Patty Senecal

February 16, 2021

**Re: SCAQMD Proposed Rule 1109.1, NO_x Emission Reduction for Refinery Equipment
WSPA Comments on Preliminary Proposed BARCT for Boiler and Heater Categories**

Figure 1: Comparison of Industrial Project Cost Indices, Normalized to Year 2000²⁸

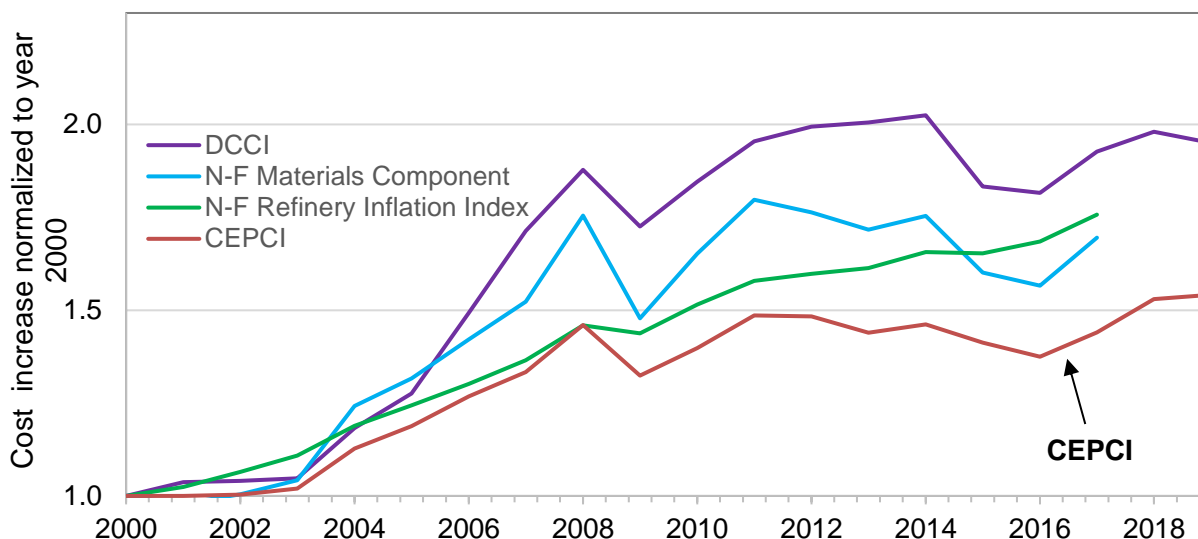
As shown in Figure 1, the CEPCI significantly understates costs when compared to the DCCI and N-F cost indices. This is important because the DCCI and N-F cost indices were actually constructed for application to the U.S. refining/petrochemical industries, whereas the CEPCI is not designed for the refining/petrochemical industries. Given that the N-F index was recently

discontinued, WSPA again recommends the DCCI should be used as a more representative index for cost escalation to estimate PR1109.1 compliance costs (and cost effectiveness). Further, because the DCCI is based on a geographically diverse selection of projects, the results of the DCCI model should be adjusted to account for the higher labor costs in California associated with additional training and qualifications requirements imposed by SB 54.

Figure 2: Comparison of Ramboll Cost Models (done for WSPA) for Boilers and Heaters to District SCR Costs Line Fit (Based on Data from Facilities) and Power Fit (Based on EPA SCR Cost Model, Adjusted to Reflect Total Cost³³) as presented at WGM #9

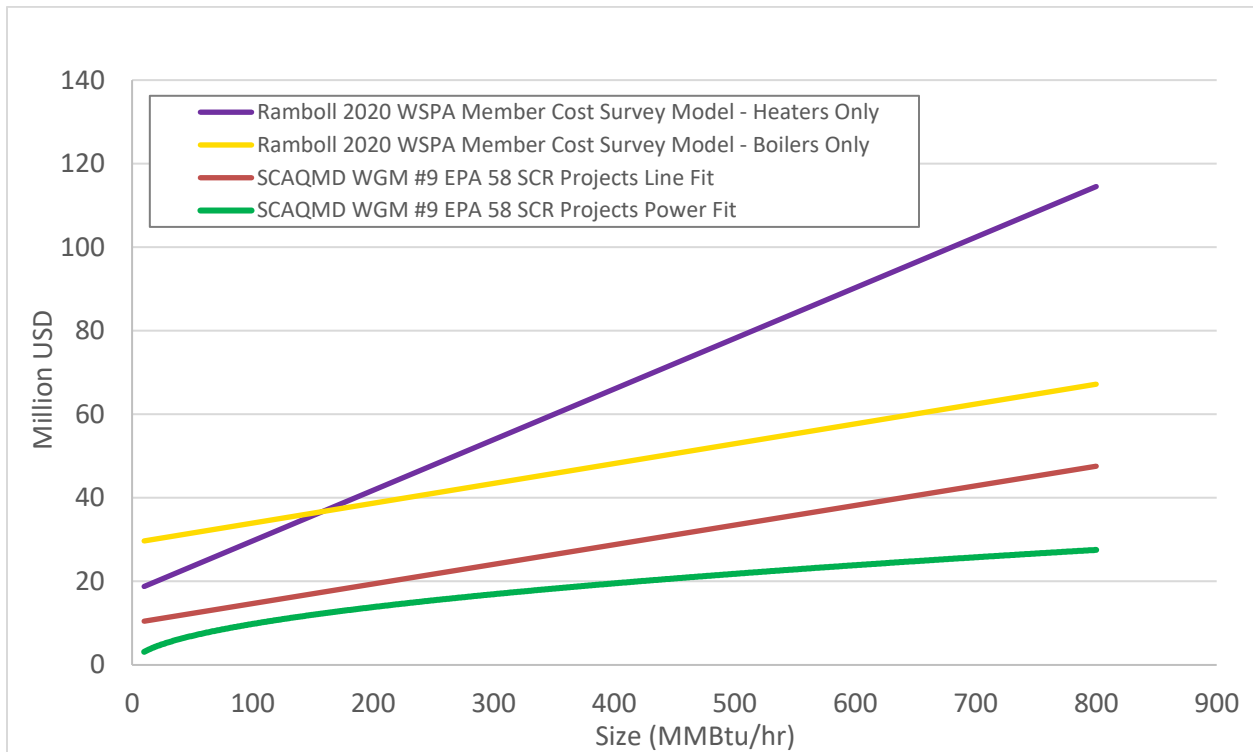
While SCAQMD updated the cost model curve used to calculate capital cost in the EPA SCR Cost Model, it still fails to fully account for compliance costs for the refinery heaters and boilers categories. The EPA SCR Cost Model is not fit for purpose. The model simply does not consider burner technology costs, and is not equipped to consider most of the other costs and considerations identified by the NEC and FERCo reports (see above).

As shown in Figure 2, the estimated compliance costs for heaters tend to be significantly higher than boilers of comparative heat input rating. We believe this is due to several factors, including higher burner counts, higher flue gas temperature of heaters, and the need to install an induced draft fan. The NEC report stated “For heaters and boilers with rated firing rates > 40 MMBtu/hr, a NOx BARCT limit of 2 ppmv will require a combination of ULNB and SCR.”³⁴ In WGM #17, the District presented that two SCR in series could also be used to achieve a 2 ppm endpoint.
